The Commission has issued the enclosed Amendment Nos. 88 and 61 to Facility Operating License Nos. DPR-52 and DPR-68 for the Browns Ferry Nuclear Plant, Unit 2 and 3. These amendments are in response to your application dated June 2, 1983 (TVA BFNP TS 188).

The amendments change the Technical Specifications to allow operation of Browns Ferry Units 2 and 3 with increased core flow during the remainder of Cycle 5 for each unit.

AMENDMENT TO FACILITY OPERATING LICENSE

SAFETY EVALUATION BY THE OFFICE OF NUCLEAR REACTOR REGULATION  
SUPPORTING AMENDMENT NO. 88 TO FACILITY OPERATING LICENSE NO. DPR-52  
AND AMENDMENT NO. 61 TO FACILITY OPERATING LICENSE NO. DPR-68  
TENNESSEE VALLEY AUTHORITY  
BROWNS FERRY NUCLEAR PLANT, UNITS 2 AND 3  
DOCKET NOS. 50-260 AND 50-296

Figure 3.5.K-1

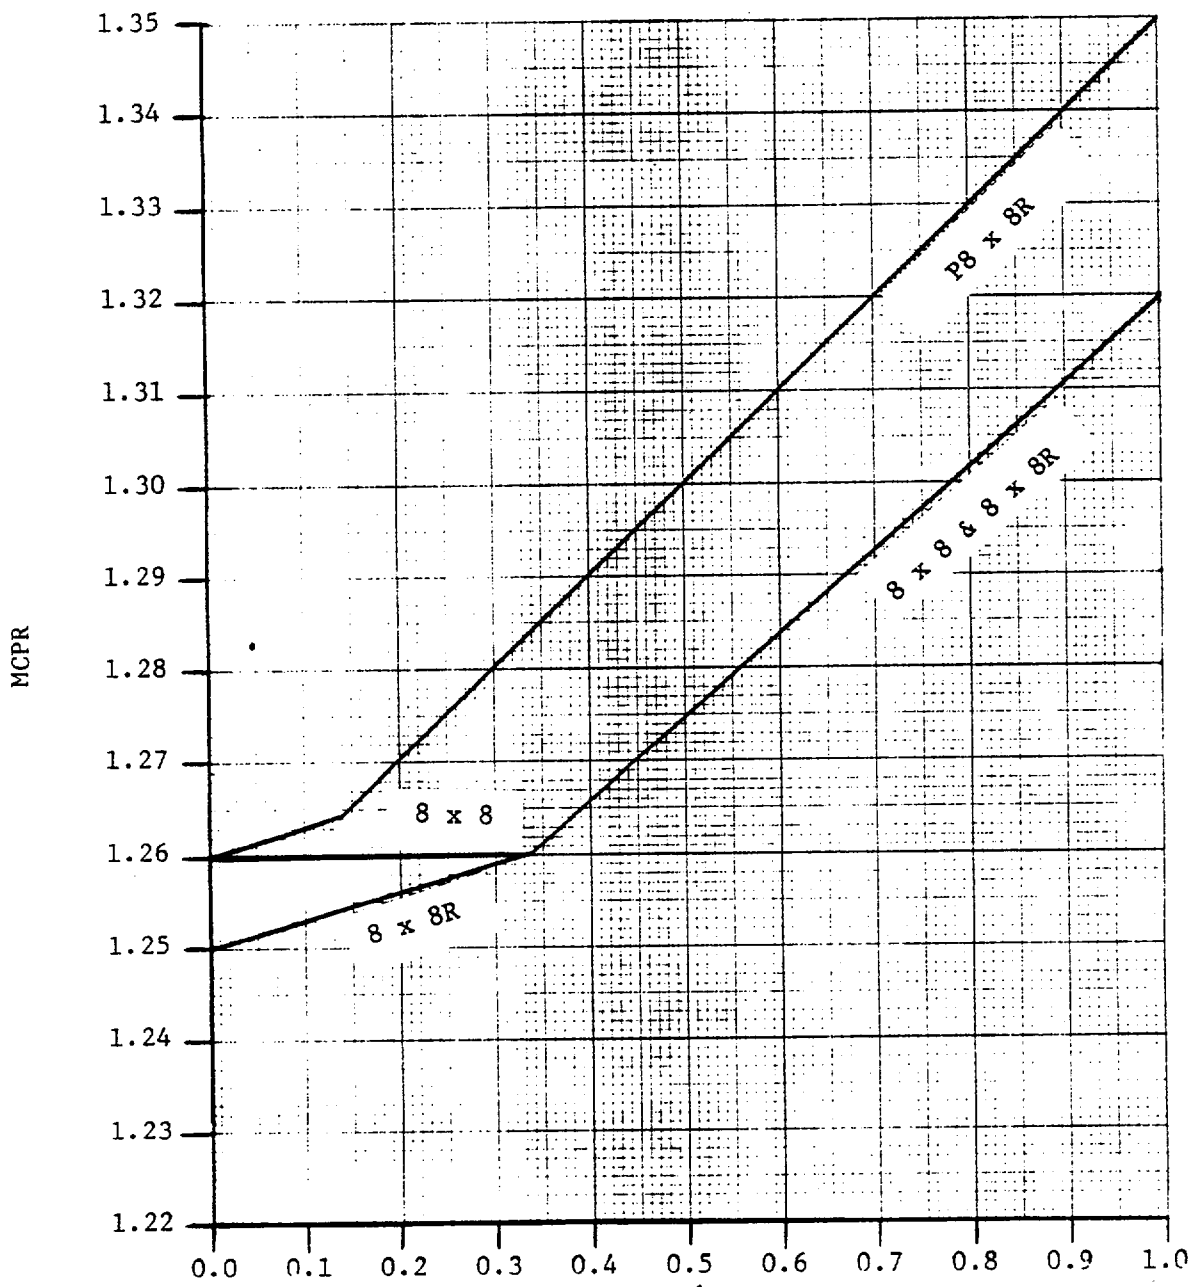
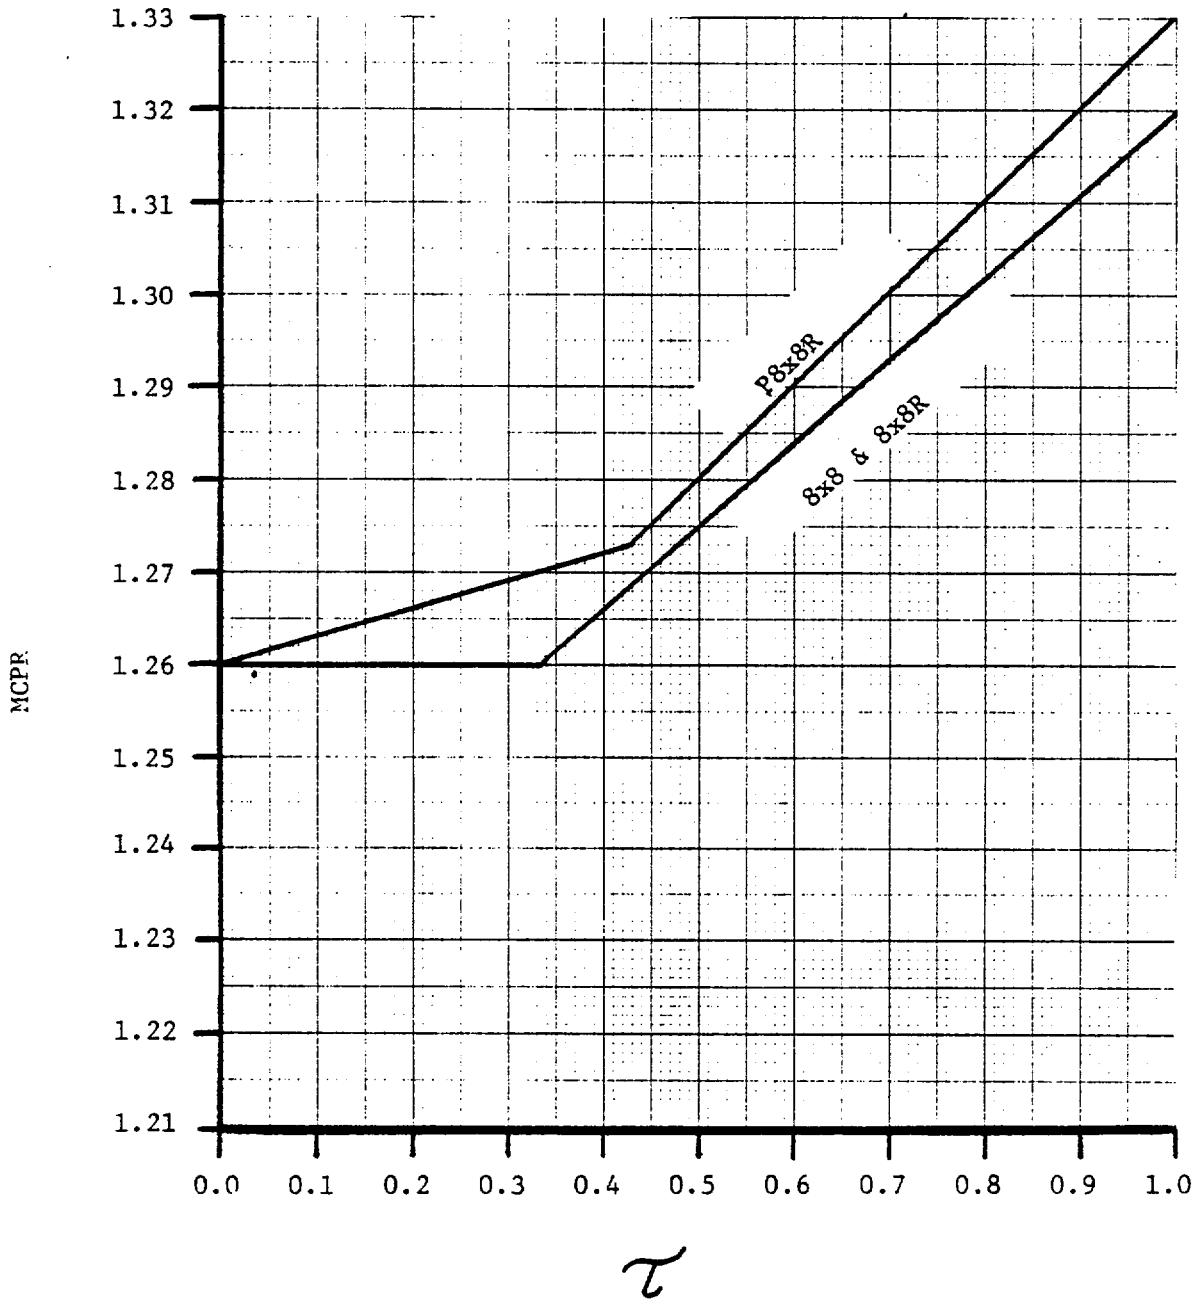
The review includes the following areas: (1) safety limit minimum critical power (MCPR), (2) operating limit MCPR, (3) thermal-hydraulic stability, and (4) changes to Figures 3.5.K-1 and 3.5.2 of the Technical Specifications.

Figures 3.5.K-1 of the Technical Specifications has been modified to include the operating limit MCPR for Cycle 5 extended flow operation. Using Option A, for Unit 2 the operating limit MCPRs shall be 1.35 for P8X8R fuel, and 1.32 for 8X8 and 8X8R fuel; for Unit 3 the operating limit MCPRs shall be 1.33 for P8X8R fuel, and 1.32 for 8X8 and 8X8R fuel types. Using Option B, for Unit 2 the operating limit MCPRs shall be 1.26, 1.26 and 1.25 for P8X8R, 8X8 8X8R fuel types, respectively; for Unit 3 the operating limit MCPRs shall be 1.26 for P8X8R, 8X8 and 8X8R fuel types. Figure 3.5.2 has been changed to include a note to reflect that the  $K_f$  factor is equal to 1.0 for core flows greater than or equal to rated core flow.

We find thermal-hydraulic methods have been used which have been approved generically by Reference 4 and that the results of analyses support the proposed limit MCPRs, which avoid violation of the safety limit MCPR for design transients. We, therefore, conclude that the core flow increase beyond the rated flow will not adversely affect the capability to operate Browns Ferry Nuclear Plant, Units 2 and 3 safely during Cycle 5 extended flow operation and that the proposed changes to Figures 3.5.K-1 and 3.5.2 of the Technical Specifications discussed above are acceptable.

FIGURE 3.5.2

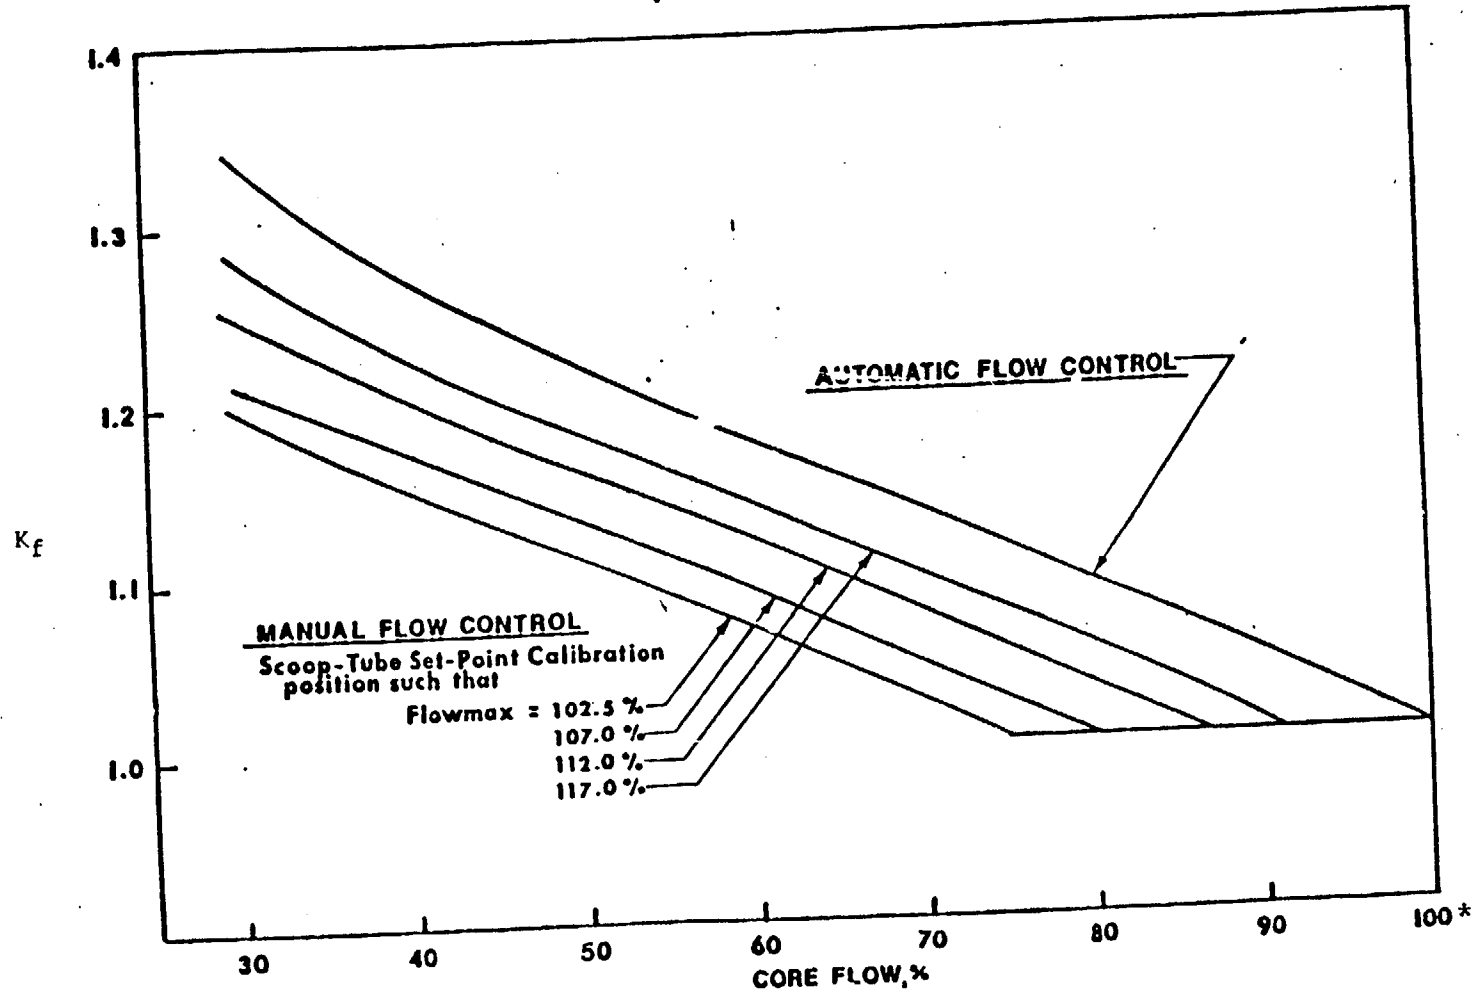
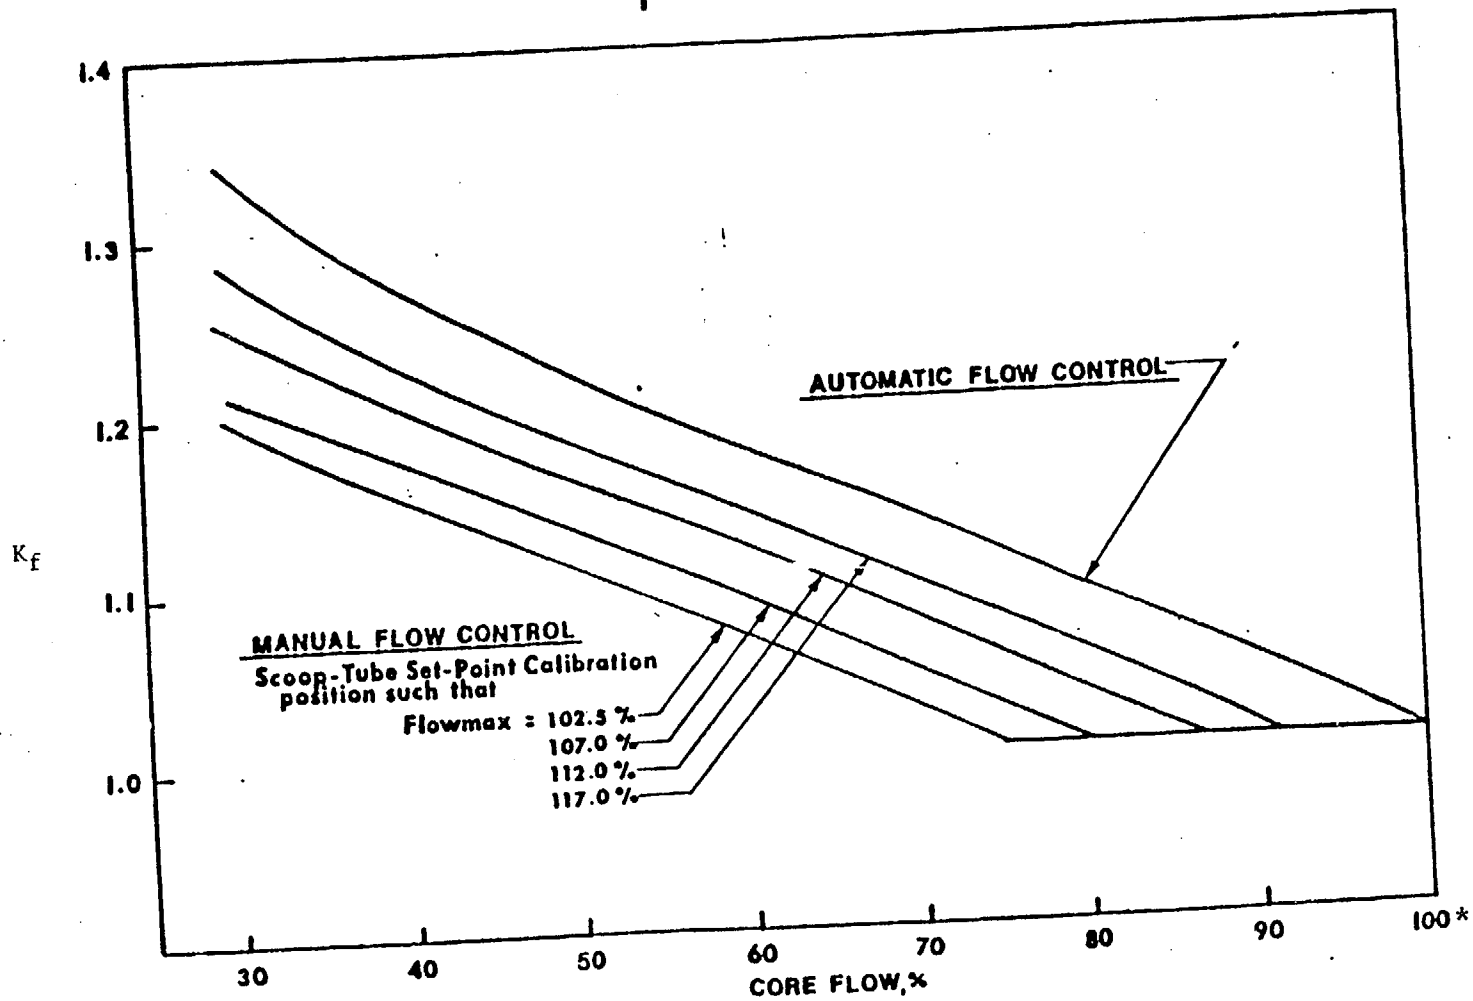
\* $K_f = 1.0$  for core flow  $\geq 100\%$ .
